S2S and Coastal Protection. Updated February 2026

Coastal Protection Measures in Dublin Bay South

1.1 Introduction:

Figure 5-2 CCA1-C Option A typical cross section

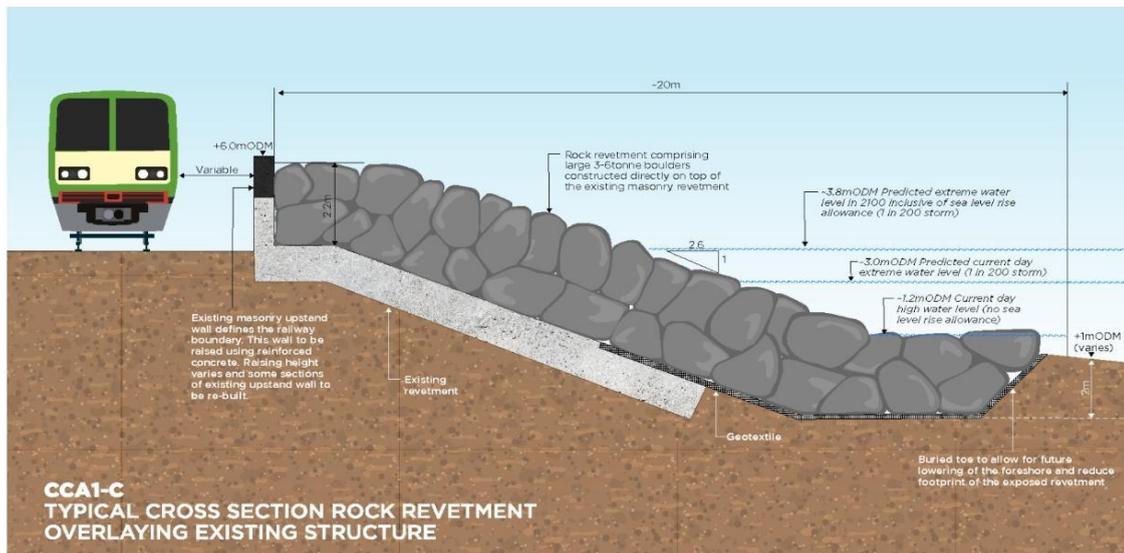
The **2024** NTA/Irish Rail study of this project concluded that a rock armour revetment was the most economic and effective way of achieving the necessary protection of the railway. **Ref. Fig 1.**

Fig 1: This shows the Irish Rail preferred proposal in 2024. It comprises a Rock Revetment with a raised sea wall as the basic protection of the Railway between Merrion Gates and Blackrock. There are other variations on it in sections between Blackrock and Dun Laoghaire

S2S suggests that NTA/Irish Rail revert to their 2024 preferred solution using rock armour, but to do so by first constructing a haul road. This is a common, practical and environmental approach that would reduce the cost and provide a permanent facility by which all the other objectives could be achieved. **Ref Fig 3**

Fig 2: This shows the new proposal in 2025- The Rock Armour is abandoned, the old sea wall demolished down to the level of the tracks and replaced with precast concrete slabs that will be about 1.3m higher than the existing wall making it about 3.0m high overall.

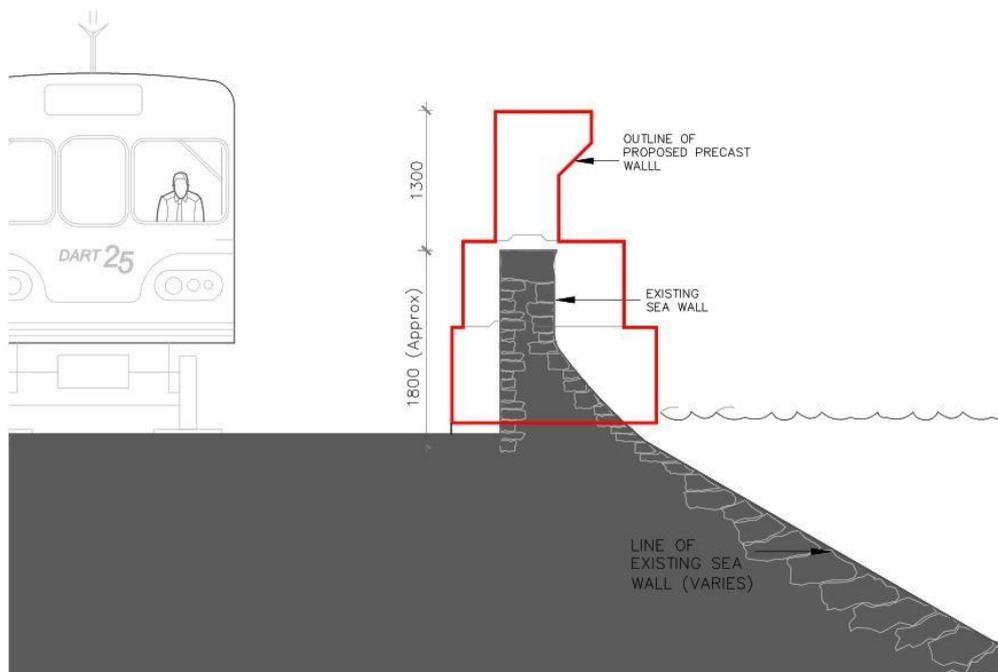
In the **2025** study that approach has been replaced by a plan to demolish the old sea wall down to the level of the tracks and to replace it with precast concrete slabs that will be about 1.3m higher than the old wall making it about 3.0m high overall. **Ref. Appendix Fig 2.** This will preclude other infrastructure objectives being incorporated. In addition, it will result in the view from the Dart being obliterated forever.

Fig 3: S2S Proposal: A similar Rock Armour Revetment including a haul road/permanent way that would accommodate a walkway/leisure cycleway and access for ongoing maintenance and repair of the railway and other infrastructure.

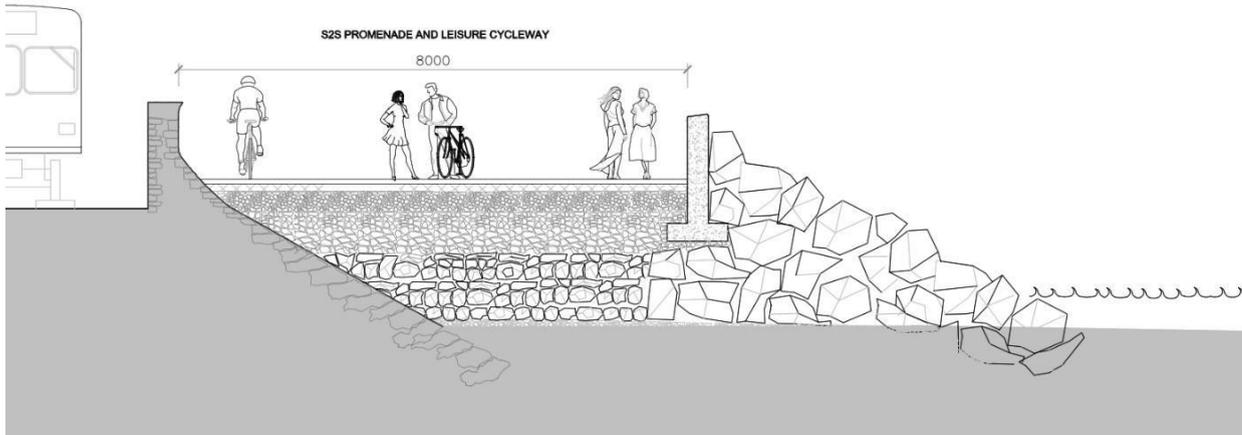
This would allow most if not all of the construction plant and materials to be brought to the worksite as the work proceeds. Critically it reduces the need to travel back and forth on the strand - with all the implications that would entail for the habitats. This is the method by which similar work has been carried out by Fingal County Council/ NTA/Irish Rail in Wexford Harbour and the Malahide Estuary. **Ref Appendix Fig 4**

Rock Armour is the traditional means of building effective marine structures - for good reasons. In a storm such as we have seen in recent days, when large waves meet a **vertical surface**, they explode up to twice or three times their original height. On-shore winds carry the spray over the top of the wall, causing flooding to the space behind. In some cases, they just knock the walls down as we have seen at Seapoint. Because of its sloping and rugged surface **rock armour** takes most of the energy out of the wave before it reaches the top - significantly reducing the over spray. By providing a space between the top of the slope and the railway line (in this case the walkway and cycleway) it allows the residual overspray to be collected and returned before it reaches the railway line.

Fig 5: The current proposed 8.5 km undersea route across Dublin Bay and an alternative 4 Km onshore route for the proposed Eirgrid 225 KV_a line from Carrickmines to Seam Moore Park. A further 1.6Km line could be laid along with the line from Inchicore to reach the substation at Poolbeg.

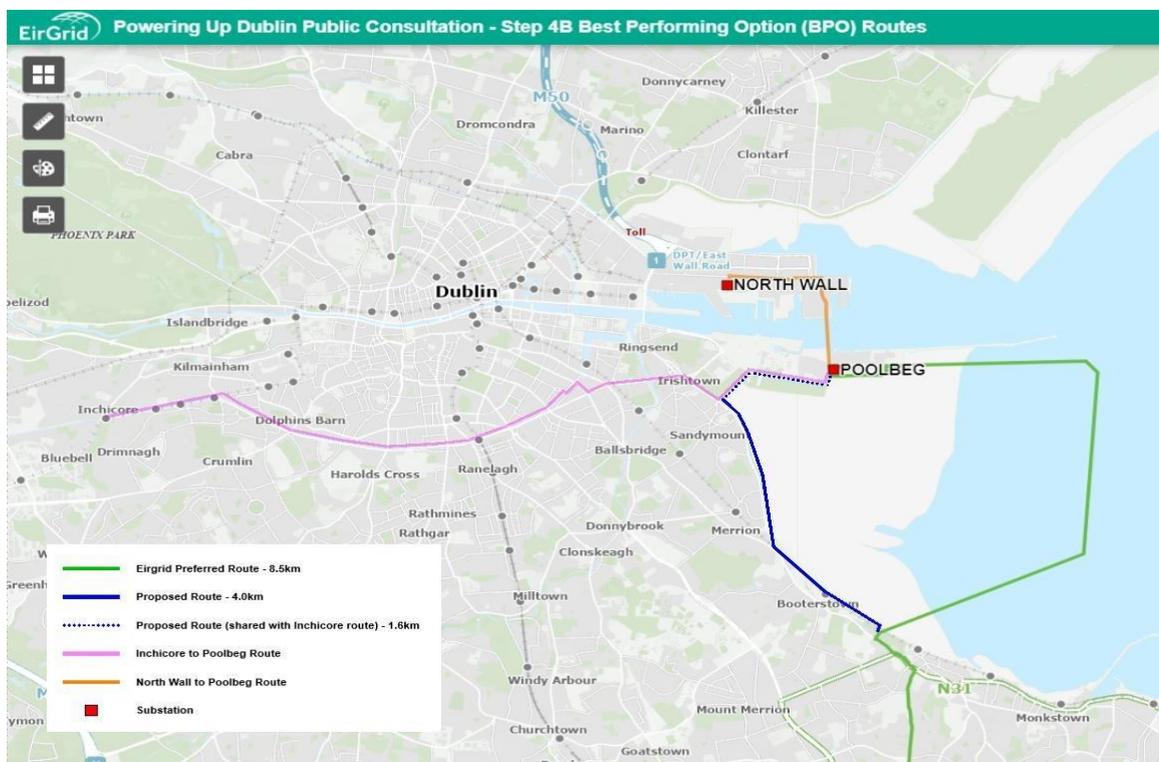
Although they have not yet reached that stage, it is obvious that all of them will have to do so before they can proceed. For stakeholders to pin their hopes on a single solution at this stage will inevitably lead to problems for those projects at subsequent stages. The Sandymount project is proceeding without reference to its potential to resolve the issue of the badly needed cycleway. Between Merrion Gates and Seapoint, several other objectives are being ignored, most importantly the 225KV_a Carrickmines to Poolbeg electrical link by Eirgrid. This is proposed to be laid in an 8.5km route in the seabed in Dublin Bay.

The same cable could be laid in a duct installed under the haul road along the coast. It could be incorporated in the works to the sea wall, it would be about 4kms long and be achieved at much less cost. All of these projects could be achieved by starting with a haul road. This creates a multi-function asset that would enable the protection of other public and private assets such as the ongoing planning by DLRC for Blackrock Seafront, Maretimo, Brighton Vale and Seapoint, all of which are currently excluded. Once the basic haul road is complete it would allow much of the finishing construction work to proceed every day, regardless of tides. It has the potential to significantly reduce the time and cost required to complete the work on all these projects individually. It could provide a route for the installation of public services and the routine maintenance of the railway and other public assets. Ref. Fig 5 and 6
